December 13, 2016

NL-16-2631

Vogtle Electric Generating Plant – Unit 2
Exigent Request to Revise Technical Specifications LCO 3.7.9 for a One-Time Change to
Support a Unit 2 Nuclear Service Cooling Water Transfer Pump Repair

VEGP Unit 2 Simplified NSCW Drawing

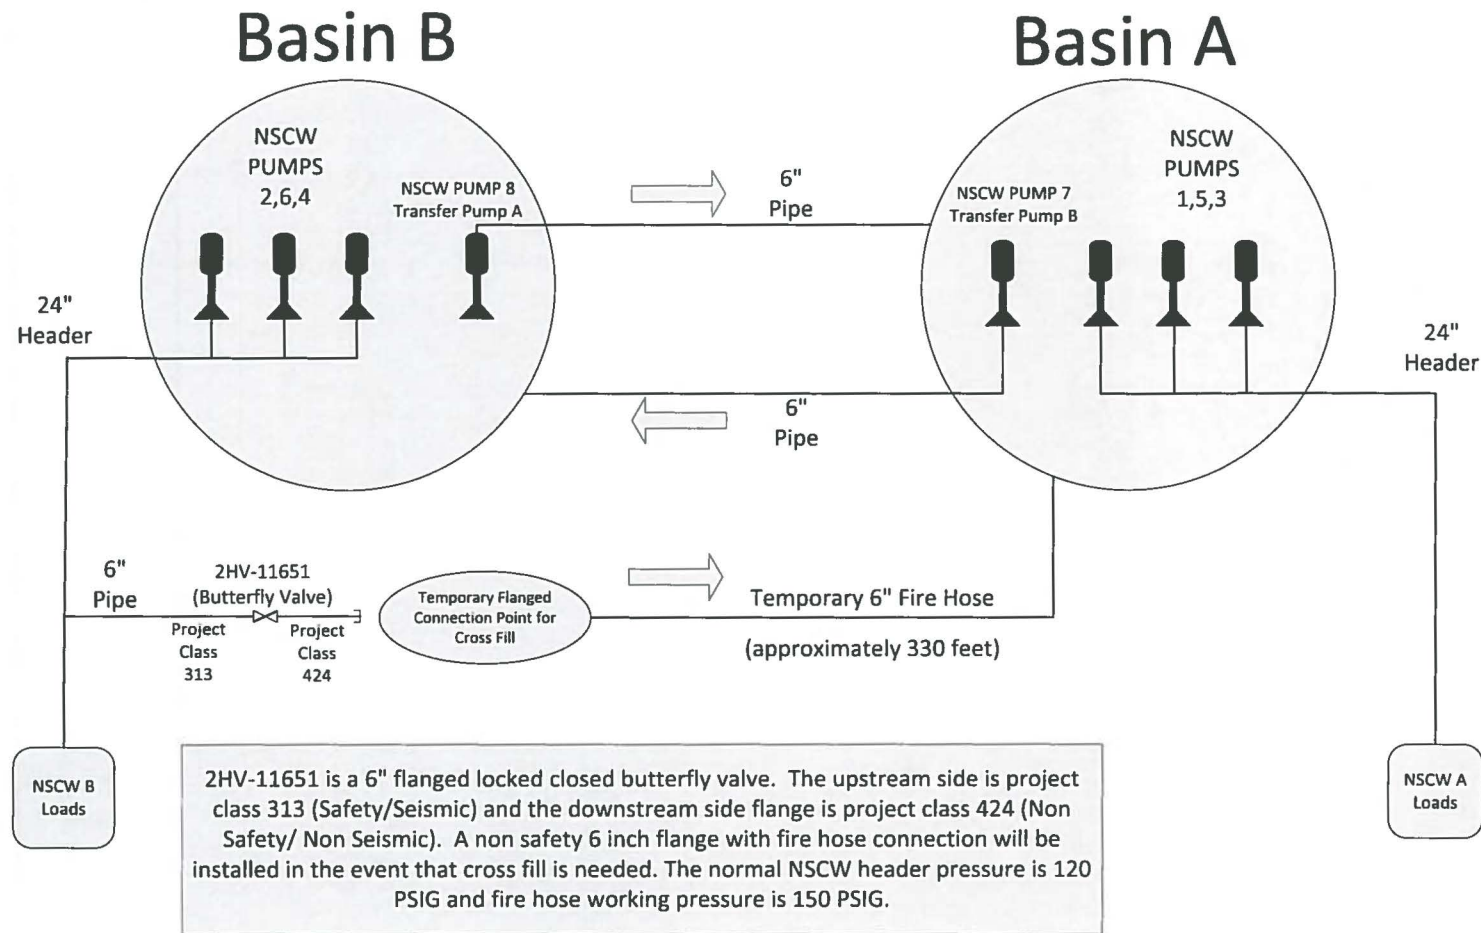
To satisfy the requirements for TS 3.7.9, Required Action D.2.1, an alternate method of basin transfer has been implemented during repair of the 2A NSCW transfer pump. The alternate method utilizes a B-Train NSCW pump, the NSCW cross-tie fill connection, and a 6 inch hose staged for routing along the ground to the A-Train NSCW tower. This compensatory measure ensures that a 30-day inventory of NSCW water is available during a design basis accident.

A simplified drawing of the NSCW system, which shows the alternate method of basin transfer, is provided at the end of this enclosure.

The alternative means for 2A NSCW water transfer consist of routing a fire hose from the 2B NSCW Tower to the 2A NSCW Tower. The fire hose is connected to the 2B NSCW cross pumping flange and will be routed to the 2A NSCW Tower.

In support of the plant's readiness for implementing the alternative means for NSCW transfer, the fire hose will initially be connected to the flange for cross pumping. In the case of an event, doors will be propped open and the fire hose routed to the 2A tower in support of NSCW transfer.
